Hope Creek Generating Station
Facility Operating License No. NPF-57
NRC Docket No. 50-354

Subject: Response to Request for Additional Information
Request for License Amendment - Extended Power Uprate

Extended Power Uprate Response to Request for Additional Information

Figure 14.110.5b. Comparison of harmonic and transient solution with adjusted initial conditions. Dashed red line – transient, solid blue line – harmonic. Node 88252.

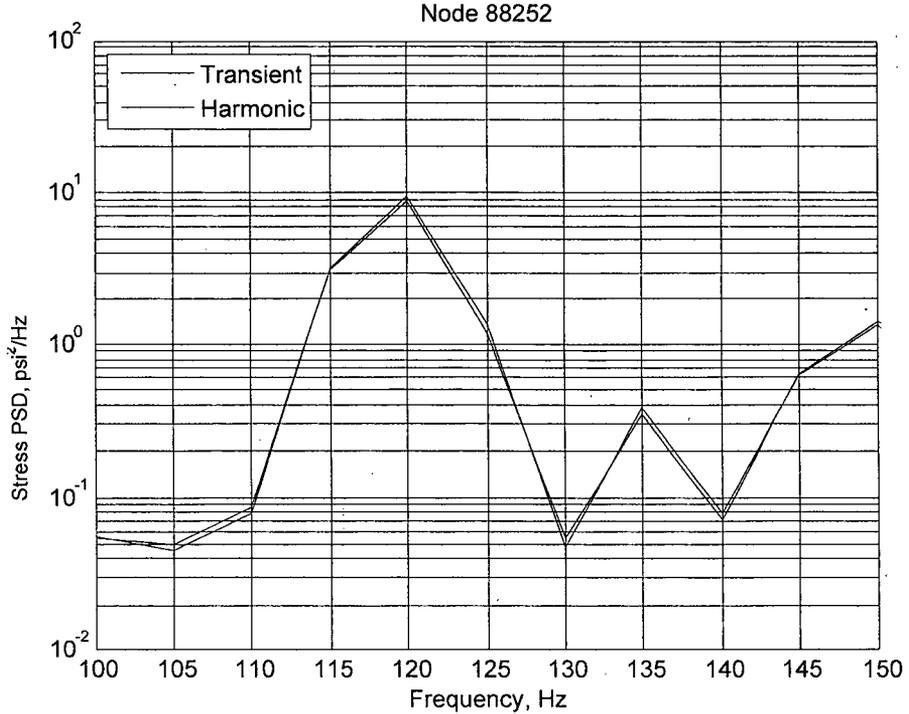
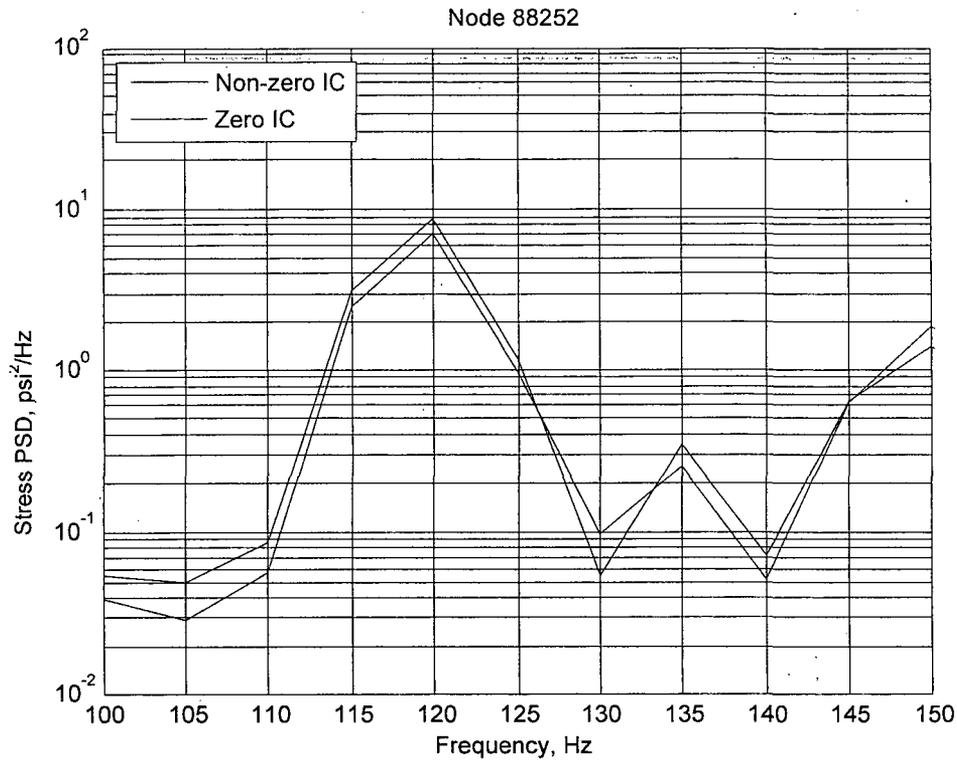
]] when analyzing a full steam dryer model. PSEG could consider an alternative analysis to verify the new approach. For example, a small section of a steam dryer could be analyzed, such as one of the outer hoods, using actual plant loads (such as those from CDI report 07-17P) over all frequencies. The outer hood boundaries could be constrained with pins or clamps. The model should retain the dynamic characteristics of the larger steam dryer model, such as having closely spaced natural frequencies. The analysis should include the following aspects:

- (a) One percent Rayleigh damping would be used for the transient simulations. Estimate the actual damping value at each natural frequency of the simplified model (i.e., small section of dryer) and use them in performing new frequency based simulations. Stress and displacement time histories at high stress locations from both approaches would be compared [[
]]. Maximum stresses and displacements for both approaches would then be compared at several locations on the hood.

- (b) Along with comparing time series computed using the transient and frequency based simulations for a model like the one described in part (a), PSEG should provide comparisons of Fast Fourier Transforms, as specified in the original RAI, and explain any differences between peak levels.

- (c) Reevaluate the frequency simulations considered in Part (a) of this RAI with 1 percent of the critical damping for all the frequencies and the compare the results for high stresses, displacements and alternating stress ratios with those for the transient simulations presented in Part (a). Provide justification for the differences in the results.

The influence of the damping model on the computed stresses is assessed by comparing the harmonic responses at selected nodes. Specifically the calculations (i) and (ii) described above are compared. The Rayleigh damping varies from 0.72% to 1%, one expects, that the stress peaks obtained with the Rayleigh model will be between 0% to 39% higher than when using a 1% damping at all frequencies. The stress and error measures defined above are recorded at the selected nodes in Table 14.110.1. The responses are compared in Figure 14.110.1. The main observation is that the predicted maximum and alternating stresses obtained with the Rayleigh damping model are everywhere higher than those obtained with 1% damping model. This is entirely consistent with expectations. The differences at these sample locations are up to 11%. Higher differences can be expected at other locations particularly ones where the local response is dominated by a mode with natural frequency near 100 Hz. Another interesting observation is that even where stresses are very small (e.g., node 88325) the responses agree to within 9.3% error. Hence, as expected, the use of different damping models tends to scale the response rather than to introduce an additive error.

The next comparison examines the responses obtained with the same damping model (Rayleigh damping), but using different prediction methods – the transient or time marching approach and the harmonic analysis. In the transient analysis, the initial conditions (displacements and velocities) are set from the harmonic analysis results in order to minimize the presence of transients in the response. Mathematically, identical responses are expected and the goal here is to verify whether this is reflected in the computational implementation. The results are tabulated in Table 14.110.2 and depicted in Figure 14.110.2. As expected very good agreement is established overall. In all figures, the agreement is demonstrated in both phase and amplitude and, with the exception of node 86424, the response curves are virtually indistinguishable. For node 86424 (Figure 14.110.2b), the maximum error occurs towards the end of the simulation. The difference in results for this node can be attributed to:

The effect of damping (Figures 14.110.4a and 14.110.5a) is similar to that observed above in the stress time histories, i.e., the PSD corresponding to the Rayleigh damping model is generally larger since the effective damping in this frequency range is smaller. From Figure 14.110.4a, the effect is seen to be frequency dependent. When using the same damping models the PSDs extracted from the harmonic and time-marching calculations (the latter being started with transient-free initial conditions) are in excellent agreement (Figures 14.110.4b and 14.110.5b). The small mismatches (recall that these results are plotted on logarithmic scales) near 100 Hz and 150 Hz are due, in part, to leakage into neighboring bins when computing the PSD. Finally, the PSDs obtained from the transient simulations initiated with the transient free solutions and with zero initial conditions are compared in Figures 14.110.4c and 14.110.5c. These plots

Figure RAI14.118.1: Comparison of Quad Cities (QC), Browns Ferry (BF), Hope Creek (HC), and Susquehanna (SQ) main steam line data.

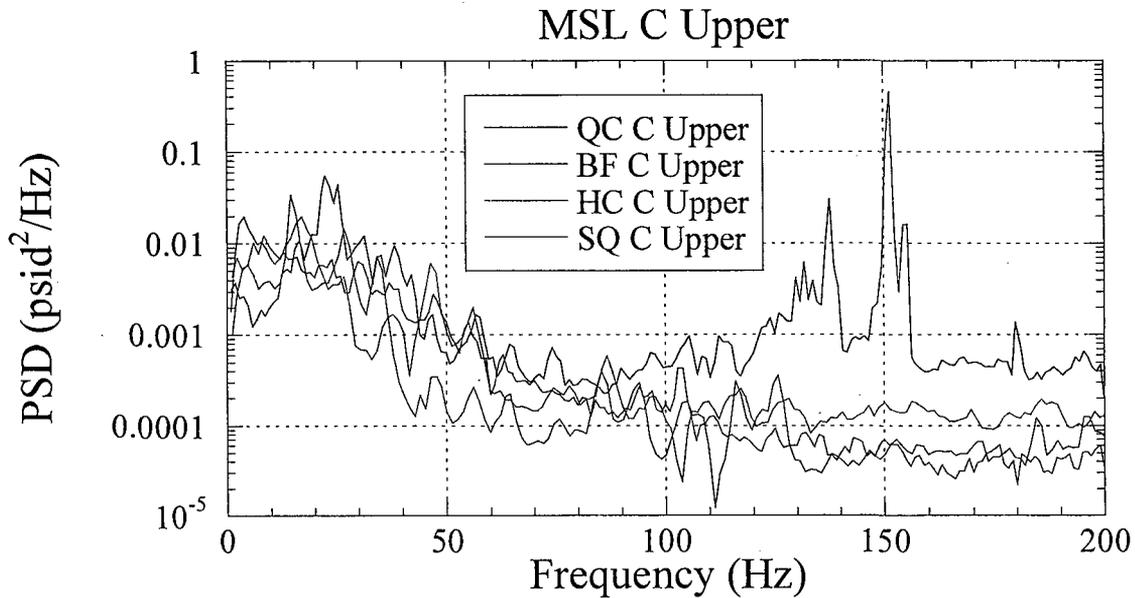
]]. The new version of ACM Rev. 4 needs to be validated against data from additional dryers exposed to strong low frequency loading. PSEG is requested to provide validation of this new methodology against additional dryer data.

Examining steam line data between Quad Cities and Hope Creek (see for instance MSL C upper location on Figure RAI14.118.1) the low frequency pressures are greater on Quad Cities than on Hope Creek's main steam line above 15 Hz.

Figure RAI 14.119.1: Normalized PSD of entrance source strengths η' for Hope Creek CLTP conditions. The colors indicate the main steam line data plotted. Note that the 80 Hz peak has been retained.

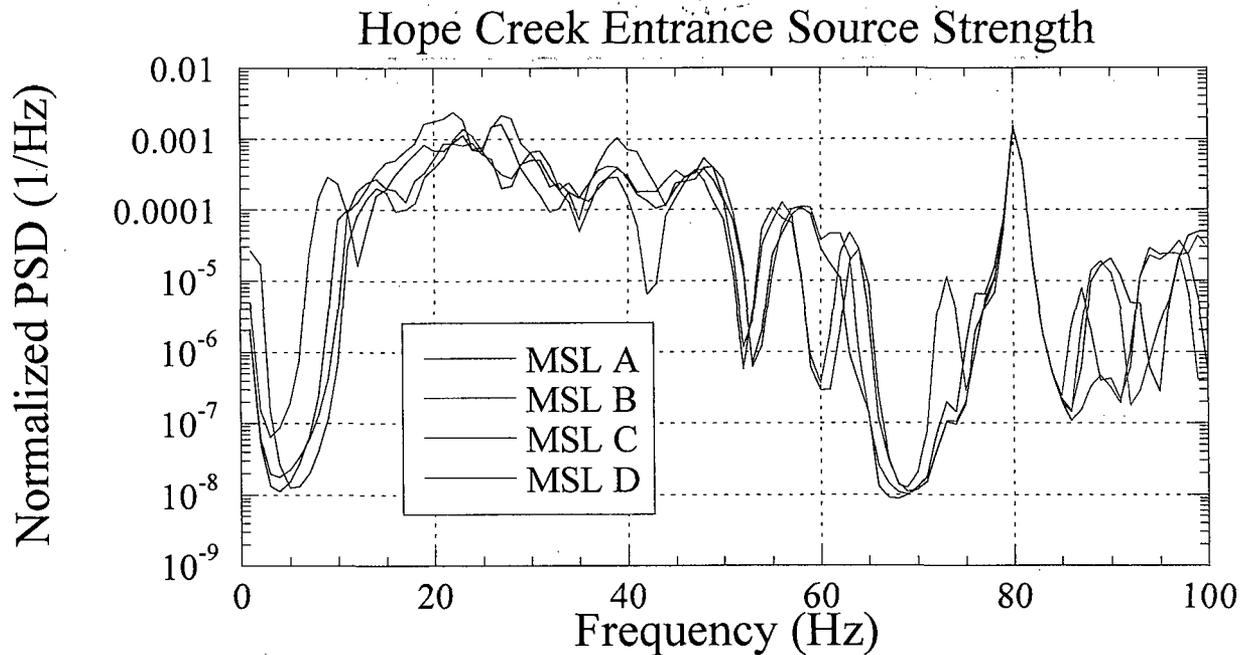
In CDI Report no. 07-18, ACM Rev. 4 is used to predict the dryer load of HC1 from strain gage measurements on MSLs. No details however are given regarding the [[
]]. PSEG is requested to provide the following:

- (a) The PSDs are shown in Figure RAI14.119.1. *
- (b) The dipole orientation is described in response to RAI 14.113.
- (c) The ACM model parameters are summarized in response to RAI 14.115.
- (d) The parameters are described in response to RAI 14.114.

*Note that below 10Hz these dipole source strengths are lower than those at Quad Cities. However one should not necessary conclude that the low frequency loads will be lower as well since the low frequency loads result form both a monopole and dipole source.
